THE SUPERHEATER CO LTD BUSH HOUSE LONDON W C 2	
TITLE	ARRANGEMENT OF SUPERHEATER "R.B" TYPE.
REVISED	DRAWING NO 2
ORDERING	6117M 2/11/34
6118M 2/11/34	MN 5160
JOHN DICKINSON & SONS LIMITED	
CONTRACT NO 255 AND 256	
CONTRACT NO 260 AND 261	
CONTRACT NO 271 AND 272

SCALE
1" = ONE FOOT
DWG NO 101X/34
3/11/32

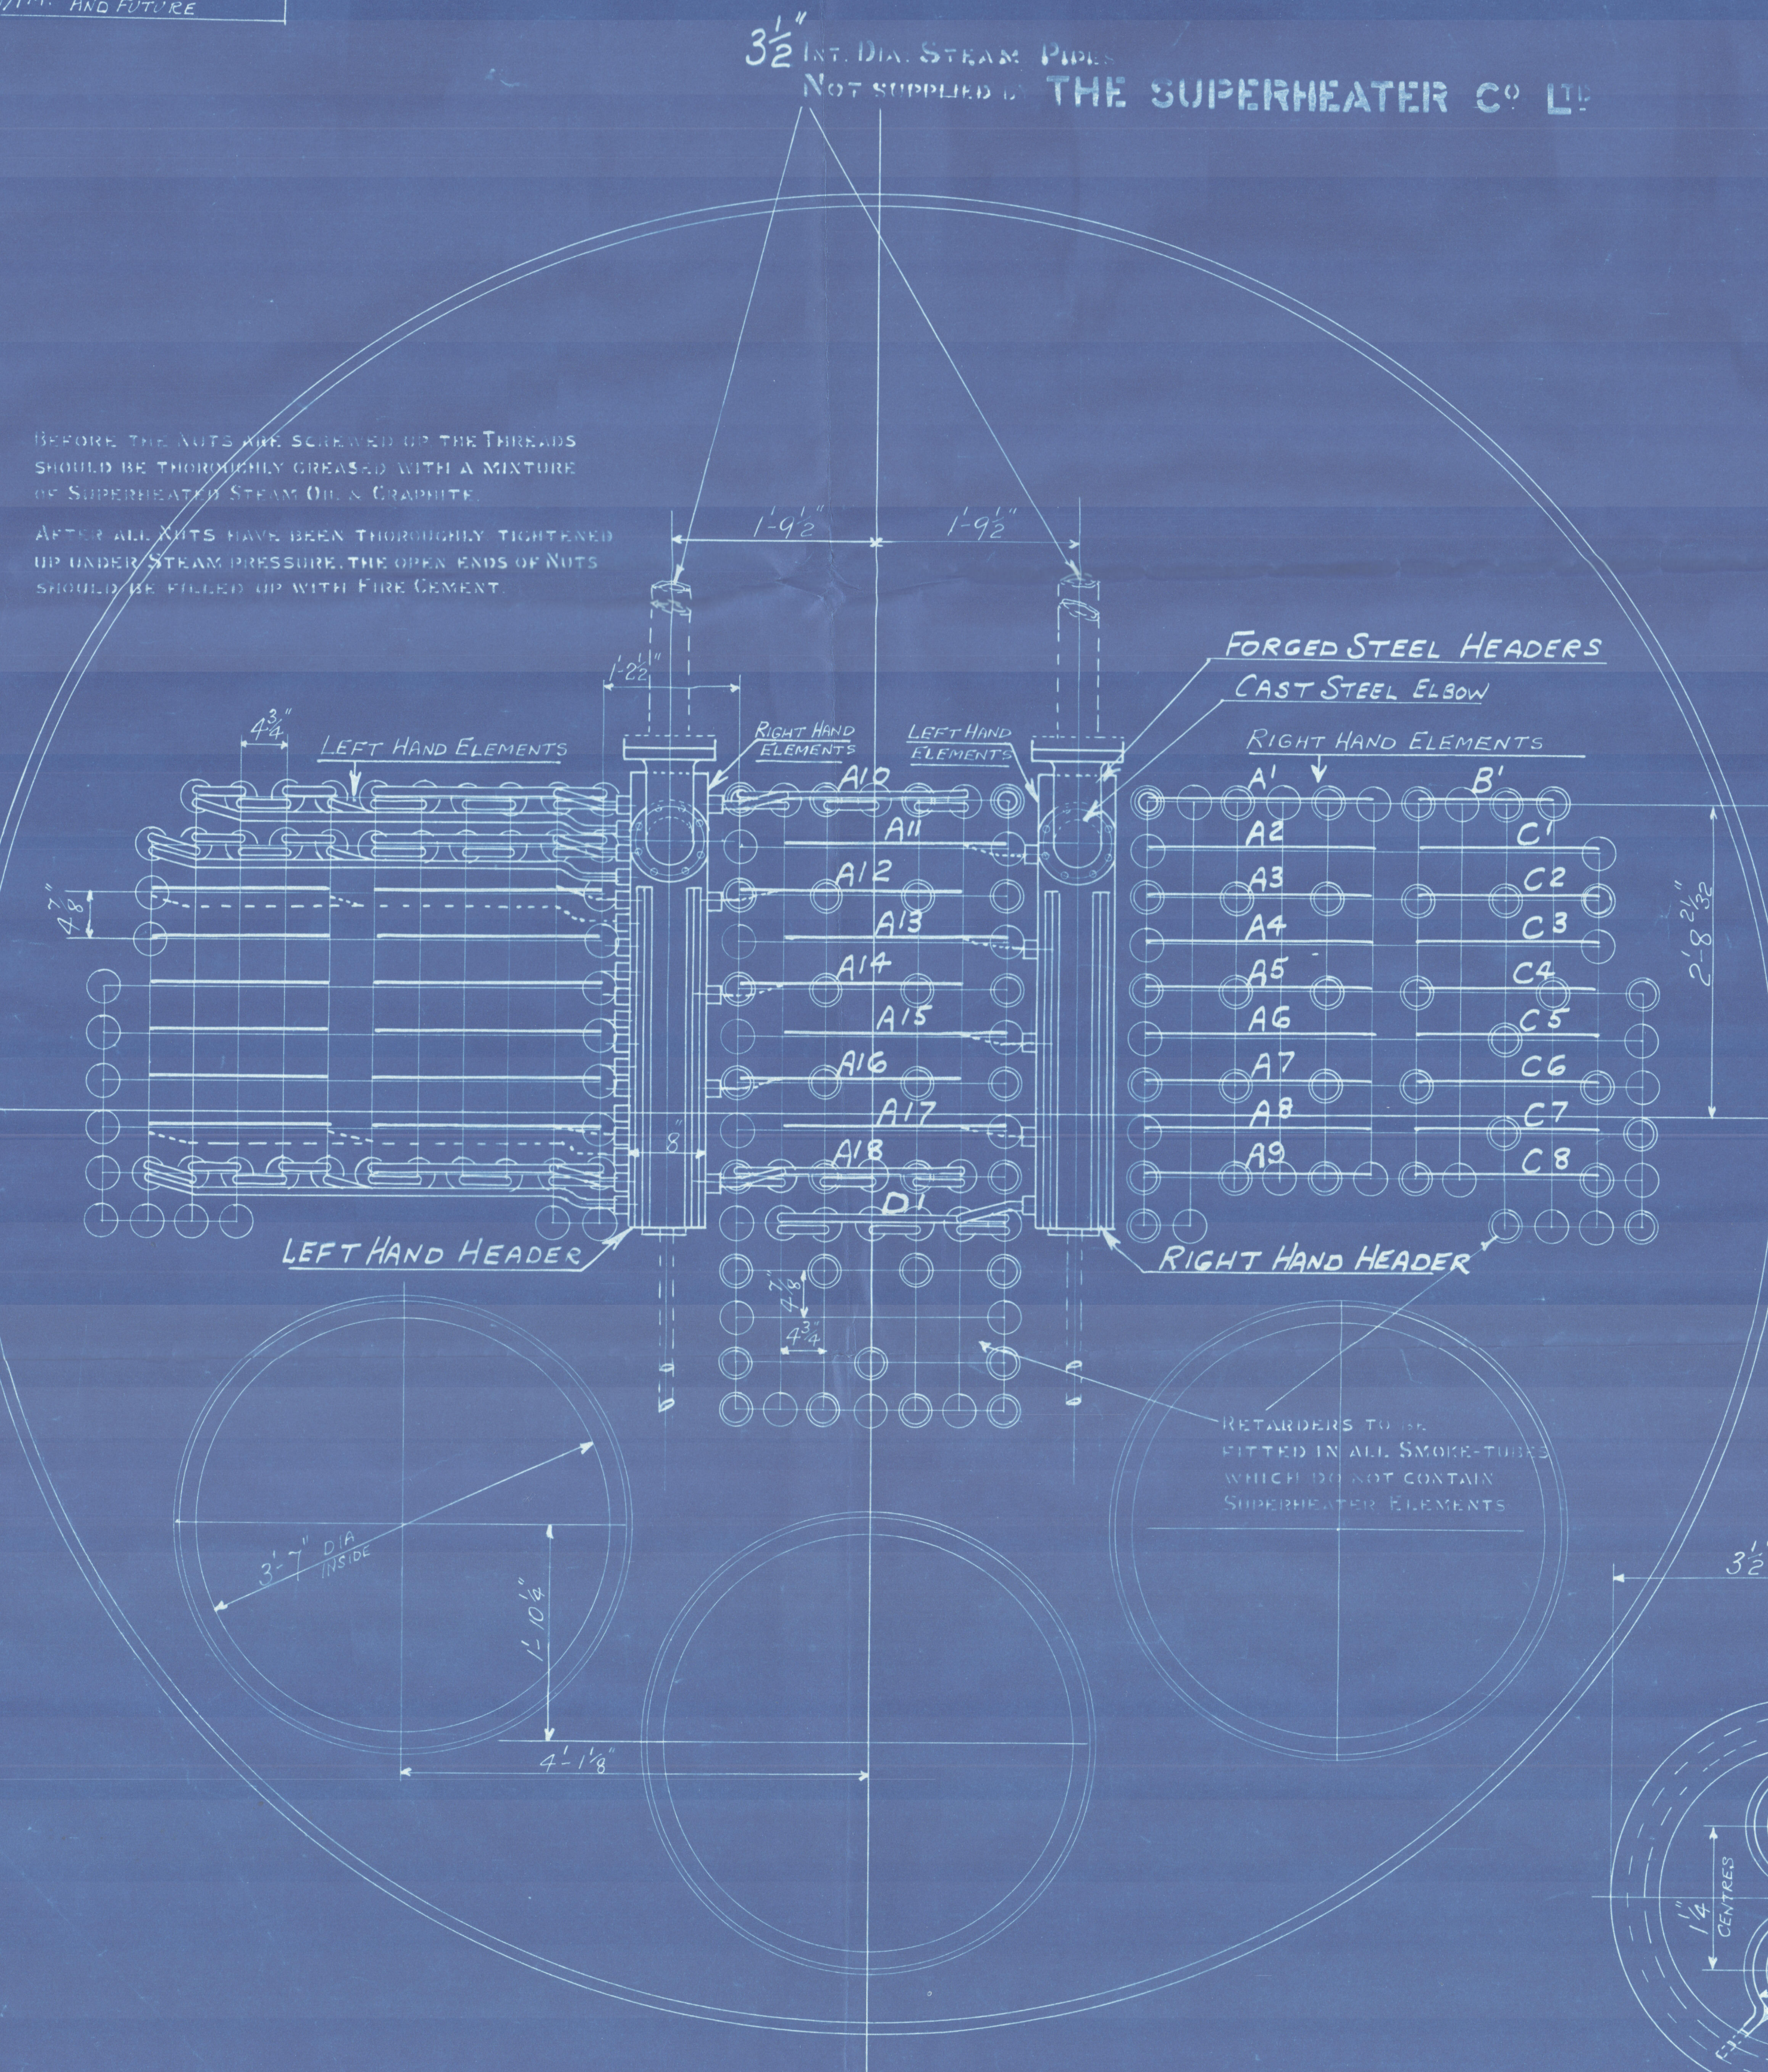
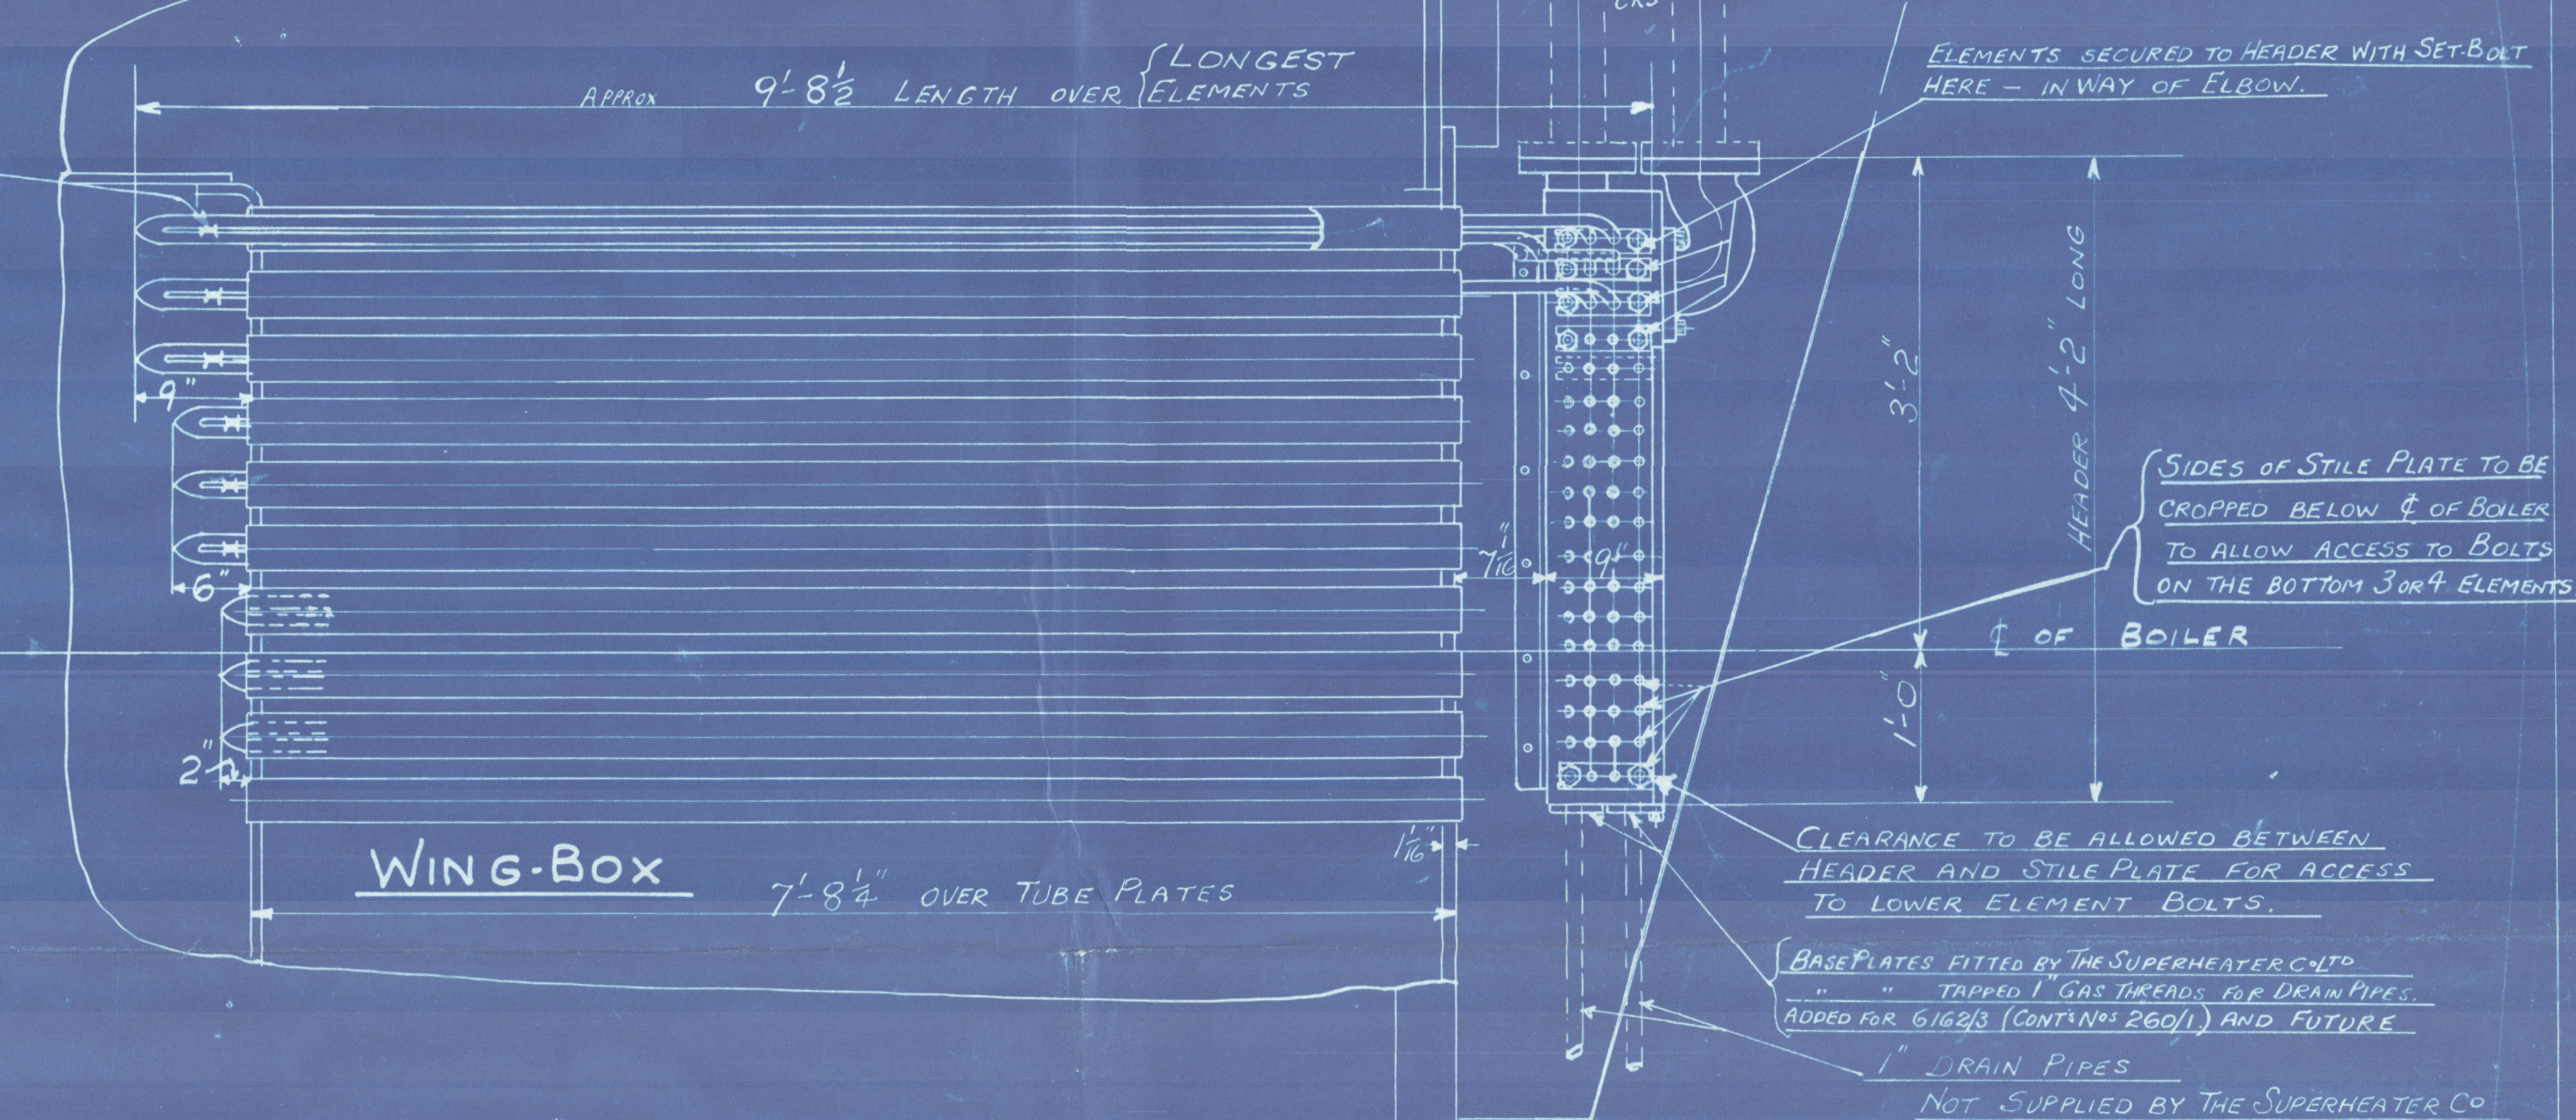
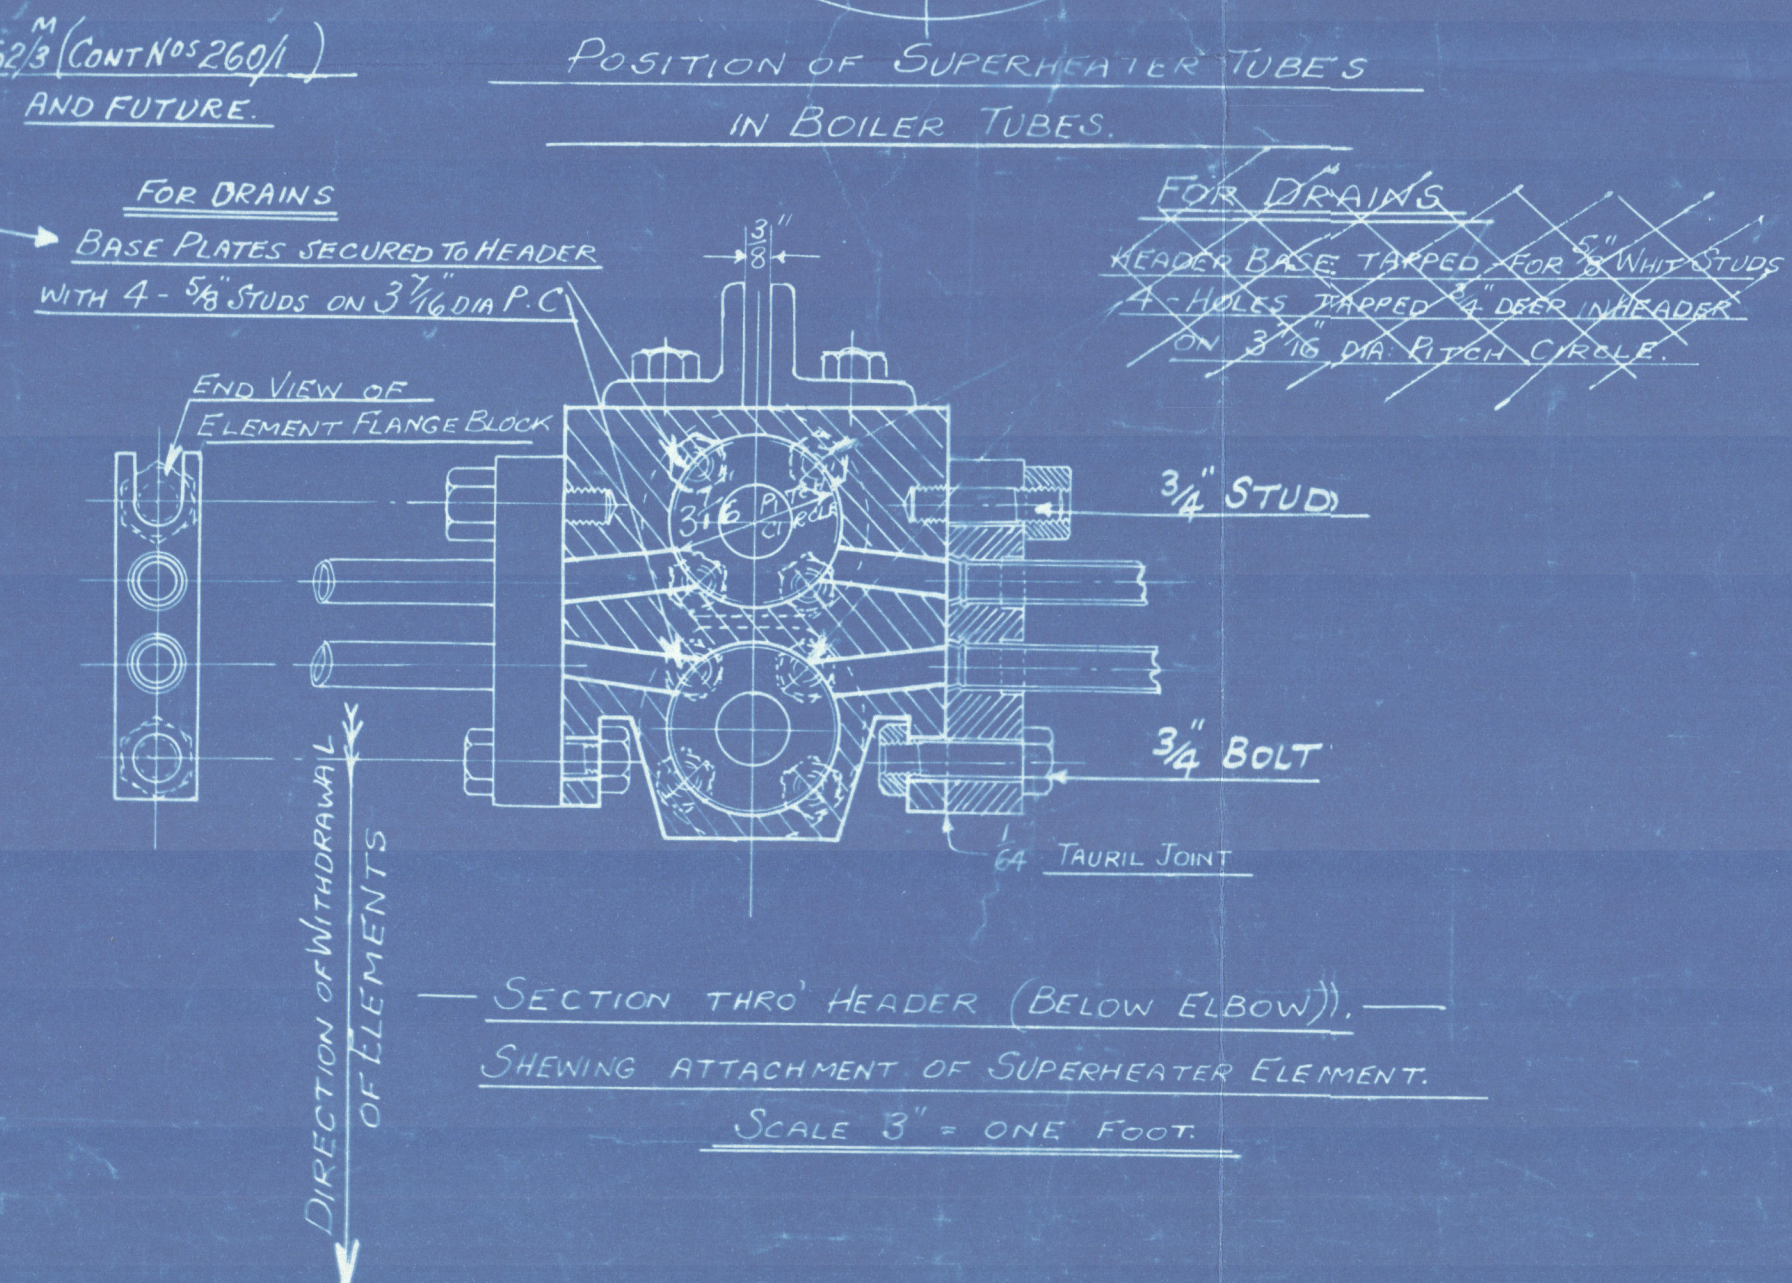
REVISION	REMARKS
(A)	ELEMENTS EXTENDED INTO COMBUSTION CHAMBER
(B)	BASE PLATES ADDED FOR 6162/3M, (NOTING 260/1)
(C)	HEADER & ELBOW FLANGES ALTERED FOR 6360/1M AND FUTURE
